Access Compliance Report

Public Rights-of-Way

Intersection ID: 27855	Main Street: LUNDIN_LINKS_LN	Cross Street: PINE_VALLEY_CLUB_DR	Location: NE
ADA ID: 2FB90D22D7D3	Ramp Type: Perp	Initial Pass/Fail: Pass	Overall Compliance: No
		Severity Score: 10

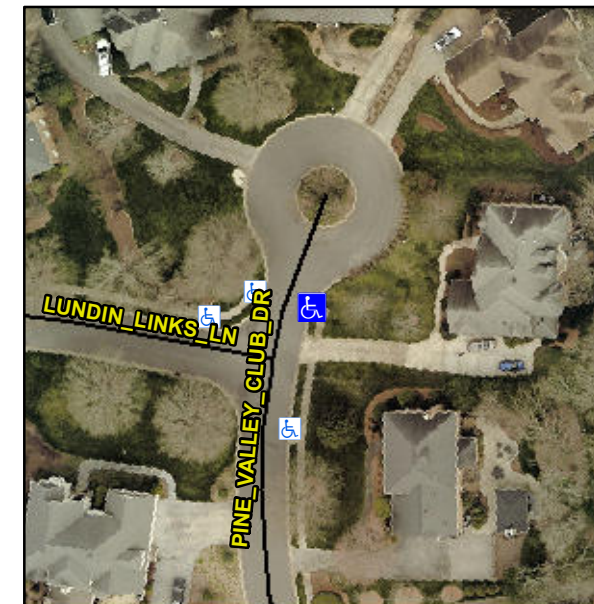
Not Found, R304.2.1, R304.2.2-Perp, R304.3.2-Para, R304.5.3

Compliance	Description	Data	Compliance	Description	Data
N/A	Ramp Length (in)	94.0	Yes	Ramp Slope (%)	6.4
Yes	Ramp Width (in)	48.0	Yes	Ramp XSlope (%)	0.5
N/A	Flare Type LT	Sloped	N/A	Flare Type RT	N/A
N/A	Flare Slope LT (%)	5.7	Yes	Flare Slope RT (%)	4.3
N/A	Flare Traversable LT?	No	N/A	Flare Traversable RT?	Yes
No	Landing Length (in)	N/A	Yes	DWS Provided?	Yes
No	Landing Width (in)	N/A	Yes	DWS Contrast?	Yes
No	Landing Slope (%)	N/A	Yes	DWS Length (in)	24.0
No	Landing X Slope (%)	N/A	Yes	DWS Full Width?	Yes
N/A	Landing Curb? (Y/N)	No	Yes	DWS Offset (in)	1.0
N/A	Shared Landing?	No			
Yes	Gutter Ponding?	No	Yes	Gutter Slope (%)	1.4
Yes	Gutter Lip Ht (in)	0.0	Yes	Gutter X Slope (%)	1.4
N/A	Painted X Walk1?	No	N/A	Painted X Walk2?	N/A
	X Walk 1 Direction	To NW		X Walk 2 Direction	N/A
N/A	X Walk 1 Width (in)	N/A	N/A	X Walk 2 Width (in)	N/A
	X Walk 1 Slope (%)	2.6		X Walk 2 Slope (%)	N/A
	X Walk 1 X Slope (%)	0.8		X Walk 2 X Slope (%)	N/A

Remove & Replace Entire Ramp.
